**The City of New York**  
**Community Board 8 Manhattan**  
*Parks and Waterfront Committee*  
*Thursday, September 11, 2025 - 6:30PM*  
*Conducted remotely on Zoom.*

**Item 1: Presentation of the plan for the reconstruction of 24 Sycamores Park – Jon Ernsberger, Deputy Director of Landscape Architecture (Manhattan), NYC Parks Capital Division**

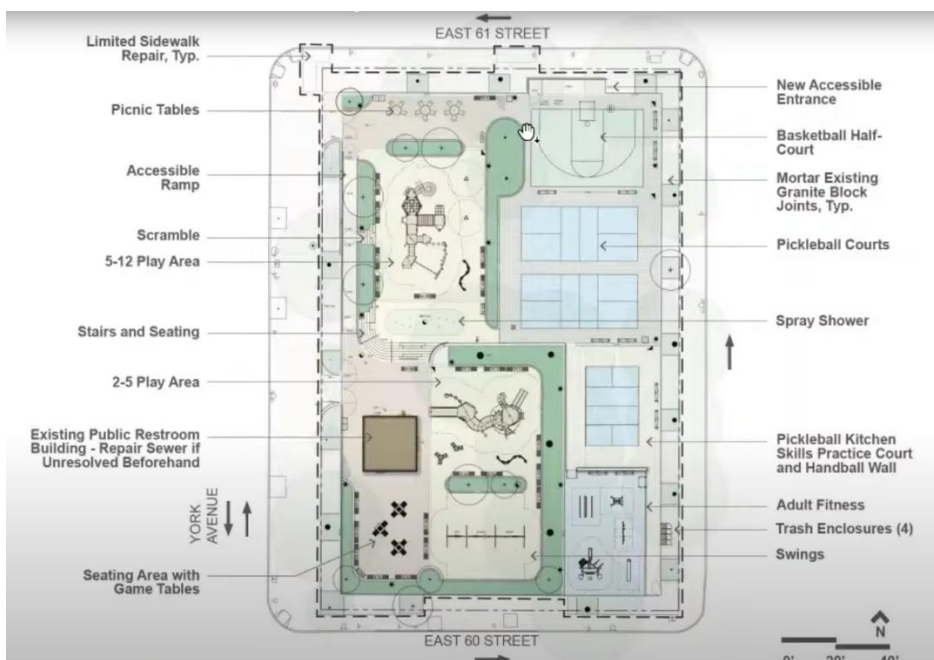
- Request permanent nets or a storage bin for a net.
- Handball court – draw pickleball line on the court (Sheena thinks it will discourage other users of the handball court).

- Increase the height of the low fences near the pickleball courts.
- Add something on the fence for people to place their rackets to reserve their court space, and suggest a space for a total of 20 people waiting.

- Put hooks or wire baskets on the fence near the pickleball court for bags.
- In response to a question about construction duration, construction will take a year, and the park will be closed during that time. Construction on the park is expected to start in a year and 6 months.

- Tree beds along York Avenue are not included in the design, Jon will explore what can be done for the tree beds.
- The handball court wall is on one side, and the other side is the adult exercise equipment area.

- Opposition was raised to the installation of permanent pickleball courts and the reduction in the number of basketball courts, which was seconded by additional members of the public. The concern is that the design takes away space for children to play and replaces it with pickleball courts used mainly by adults.

- That the two main pickleball courts should be included as permanent nets.
- Hooks should be installed with wire baskets on the 16-foot fence to hold players' paddles and equipment.
- Nets should be provided for the practice pickleball courts and stored in a wire basket and hooked on the fence when not in use.
- To consider changing the height of the interior fencing from 4 feet to 6 feet.
